RENESAS TECHNICAL UPDATE

Product Category	MPU/MCU	Document No.	TN-16C-A199A/E	Rev.	1.00
Title	Errata to R32C/151 Group, R32C/152 Group, R32C/153 Group User's Manuals	Information Category	Technical Notification		
Applicable Product	R32C/151 Group R32C/152 Group R32C/153 Group	Lot No.	Reference Document	R32C/151 Group User's Manual: Hardware Rev. 1.10 (REJ09B0503-0110) R32C/152 Group User's Manual: Hardware Rev. 1.10 (REJ09B0504-0110) R32C/153 Group User's Manual: Hardware Rev. 1.10 (REJ09B0505-0110)

This document describes corrections to the I/O Pins chapter of the user's manuals listed above.

Figure 26.1 Typical I/O Pin Block Diagram (i = 0 to 18; j = 0 to 7)

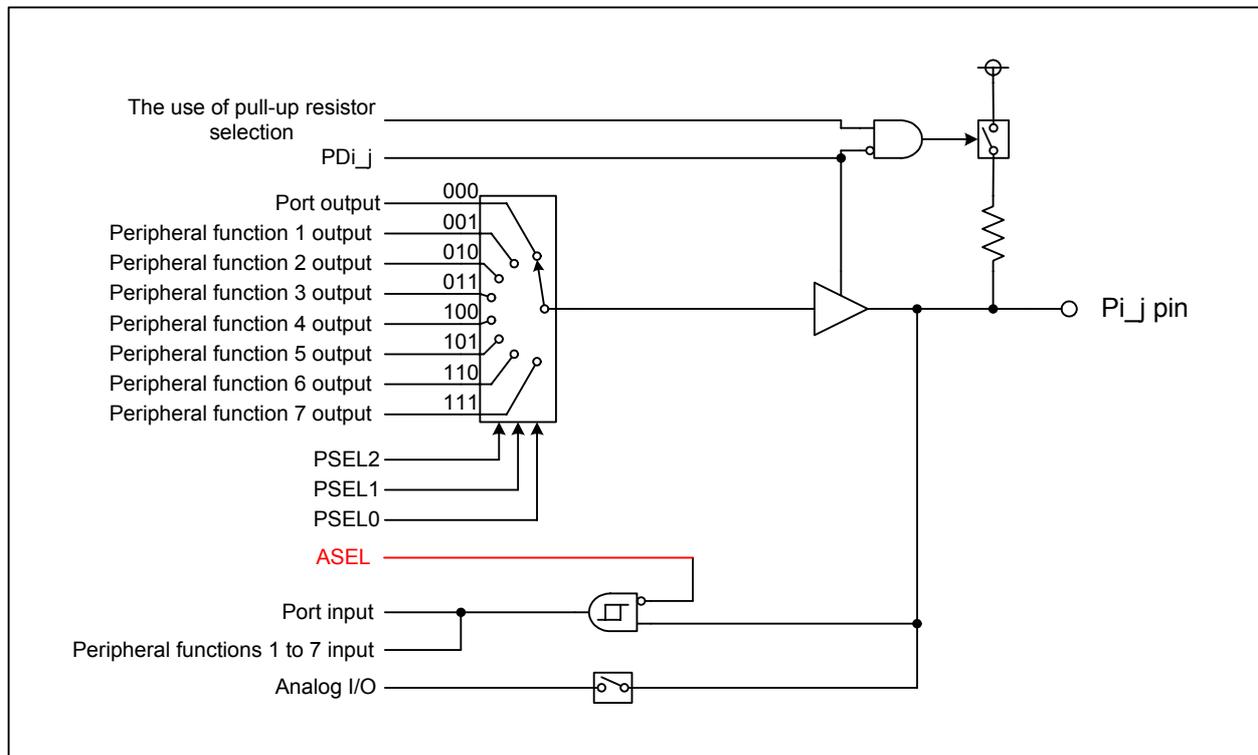
- Figure 26.1 was corrected as follows:

(The ASEL bit was deleted from conditions for separating a pull-up resistor.)
